*Fédération
Aéronautique
Internationale*

8.2 Part 2 Proposals for glider – Section 6 Part 2

Glider Aerobatics Comitty

2024-09-25

Add in Advanced

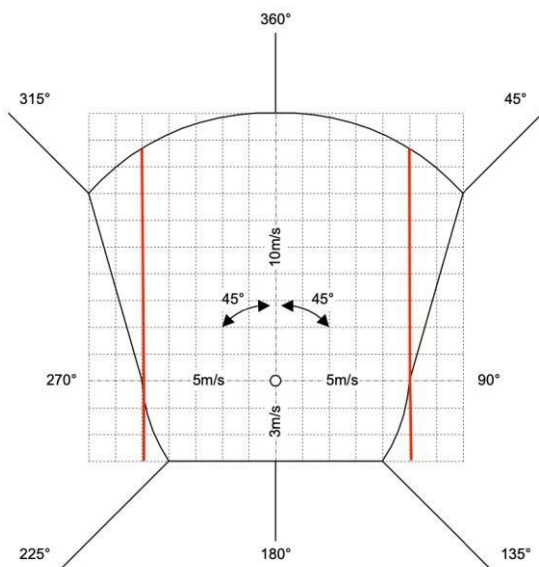
2.2.1.7. add figure 2.1.2.1 In Appendix A add 2.1.2.1

Rationale: As a 1st step of adding Rolling circle in Advanced

This part of the proposal was rejected by GAC.
